2NSW-106
Instrument Room Ventilation
Unit 3 Supply Line

INDIANA & MICHIGAN ELECTRIC CO.
DONALD C. COOK NUCLEAR PLANT

DWN: S.G.	DATE: 12-15-71	CONTAIN. VICINITY	
CKD: LdB	DATE: 2-15-72	DWG. NO. 2-NSW-106	REV. 7
ISSUED			
REF. DWG. 2-5457A

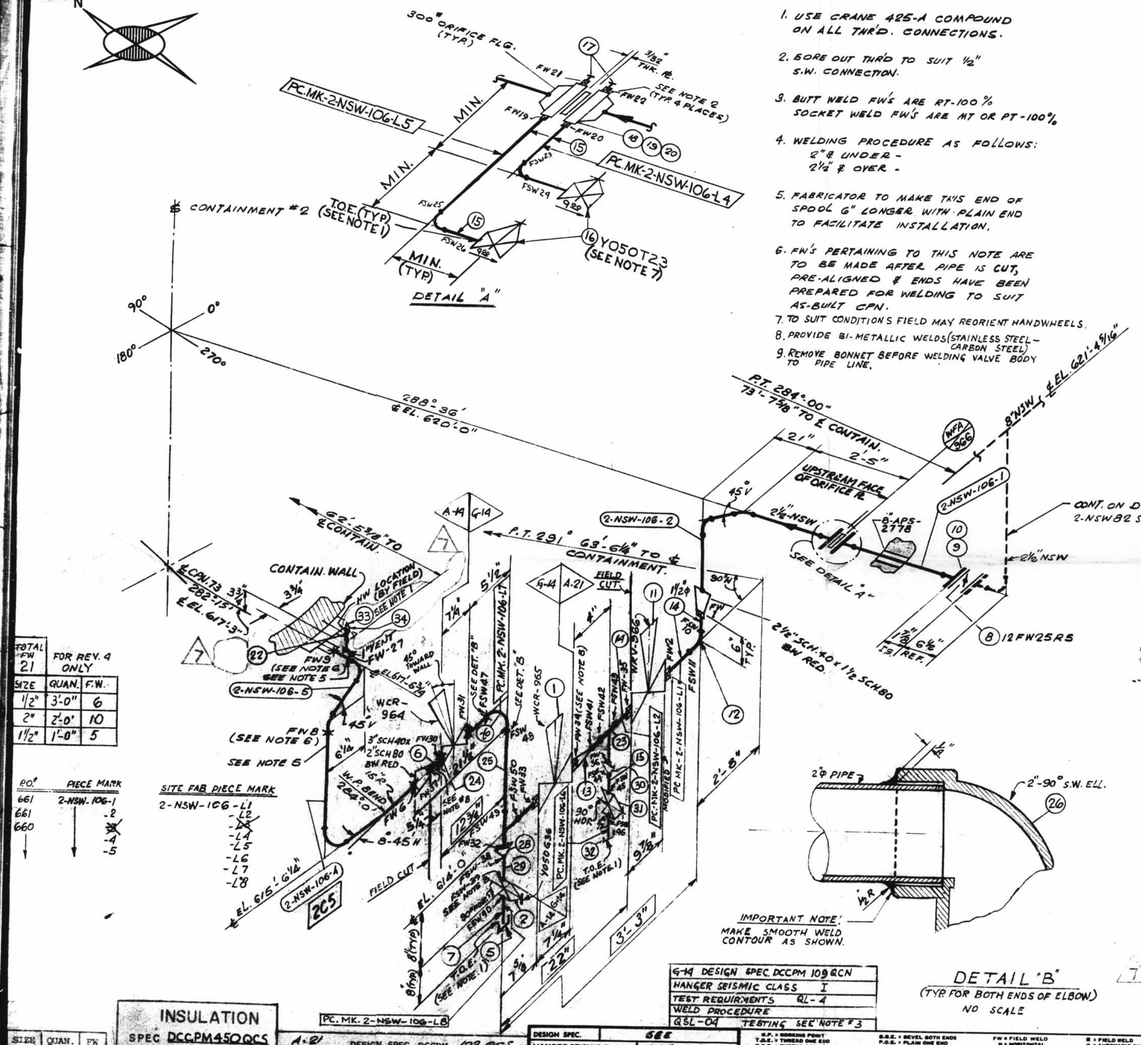
NO.	DATE	DRN CHK	DESCRIPTION	REMARKS
1	7-8-74	JM MWH	REMOVED HOLDS ON PC.MK-2-NSW-106-L4 & L5 ADDED ITEM #21 ON B/M, INSULATION STAMP PO #660 & 661, NOTE #7, # QUANTITY CHANGE ON ITEM #15 ON B/M. PER A.E.P. ARRG'T DWG. 2-5567C-1	FIELD ACTION REQ'D
2	10-16-76	PGA B.R.	REVISED BY AEP DESIGN: PER RFC-12-671: REVD: ITEM #2 Y-050G36 WAS CV-050G36. ADDED "VENT-VALVE 1/2 Y-100T23, 2" CHECK VALVE Y-200C36	ACTION REQ'D.
MF	12-2-76	D.W.	CHANGED VA. NO. TO Y200C36 WAS T36.	
4	9-1-81	K.A. D.R.	PER RFC #DC-12-2549 REPLACED ISOL VA'S WCR-964 & WCR-965 WITH DIAPH. CONTROL VA'S WCR-964 & 965 ADDED: PIPE SPEC. G-14, DIM'S, WELD BOX, FW 30-37, FSW 38-50 ITEM NO'S 23 THRU 32 TO B/M NOTES 8 & 9 PC.MK-2-NSW-106-L6, L7 & L8 DELETED ITEM NO. 3, 4 & 21 FROM B/M, PC.MK. 2-NSW-106-L3 & PC.MK-2-NSW-106-L3, REV. ITEM NO 1 IN B/M, MODIFIED PC.MK-2-NSW-106-L2.	FIELD ACTION REQ'D.
MF	7-23-81	KA LB	PER RFC #DC-12-2549 ROTATED ACTUATOR OF VALVE WCR-964 TO 15° VERT. FROM CONTAINMENT WALL	FIELD ACTION REQ'D

MF	6-11-82	KA E.G.	PER RFC-DC-12-2549 REVISED ORIENTATION OF WCR-964, BOXED DIMENSION'S INDICATE FIELD INFO. DIMS. 5'2" WAS 5'7⅛, 3⅛" WAS 3'8 & 4" WAS 6'4. ITEMS 25 & 27 WERE SCH 40S PIPE, ADDED DET. "B" & ADDED 1" PLUG TO ITEM 22 & 34	FIELD ACTION REQ'D
MF	6-16-82	WT JM	PER RFC-DC-12-2549 ADDED PLUG, ITEM 33, & RED. INSERT, ITEM 34, TO VALVE, ITEM 22, WHICH WAS Y-100T23.	NO ACTION REQ'D.
